# UNITED STATES PATENT AND TRADEMARK OFFICE

APPLICATION NO.	FILING DATE	FIRST NAMED INVENTOR	ATTORNEY DOCKET NO.	CONFIRMATION NO.
10/585,387	07/06/2006	Bian Jianzheng	16836.2	2993
22913	7590	10/11/2007		
WORKMAN NYDEGGER 60 EAST SOUTH TEMPLE 1000 EAGLE GATE TOWER SALT LAKE CITY, UT 84111			EXAMINER FERGUSON, MICHAEL P	
			ART UNIT 3679	PAPER NUMBER
			MAIL DATE 10/11/2007	DELIVERY MODE PAPER

## Office Action Summary

a stop tooth **A** (Figure 1 reprinted below with annotations) disposed on the lock plate; and

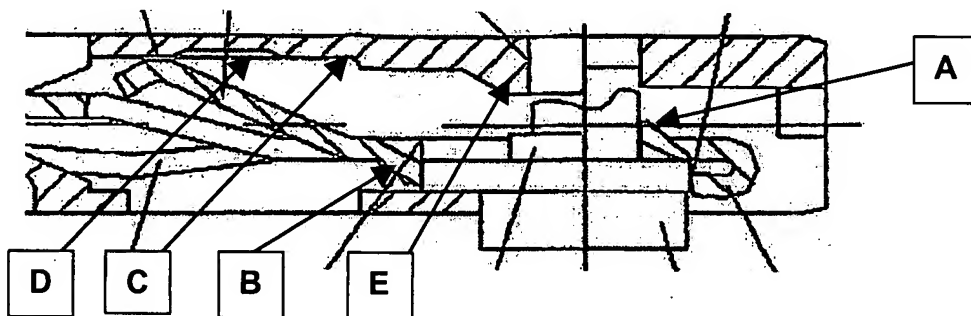
As to claim 9, Applicant's Admitted Prior Art (Figures 1-3) discloses a connecting lock for exhibition stands, the connecting lock comprising:

a lock shell **1** having inclined bearing surfaces **121,221** in a front portion thereon;

a lock plate **2** having a front end and a back end, a plurality of plate tongues **1010,1011,1012** being disposed at the front end of the lock plate, an end of each plate tongue being bent into a hook **21,22,23** with a reverse bending direction between

adjacent hooks and each plate tongue having a beveled surface, the plate tongues being separated by a plurality of elongated slots **1001,1002**, each slot being divided into three sections **41,42,43** of different widths;

an eccentric lock cam **3**, having an eccentric cam, the lock plate being inserted into the lock shell, and the eccentric lock cam being inserted through a first hole and a second hole **5**, and into a third hole **53**, wherein the first hole has an arc and the first hole and the third hole are formed in the lock shell, and the second hole is formed in the lock plate,

wherein the eccentric cam on the eccentric lock cam and the stop tooth on the lock plate constitute a stop structure (Figures 1-3).
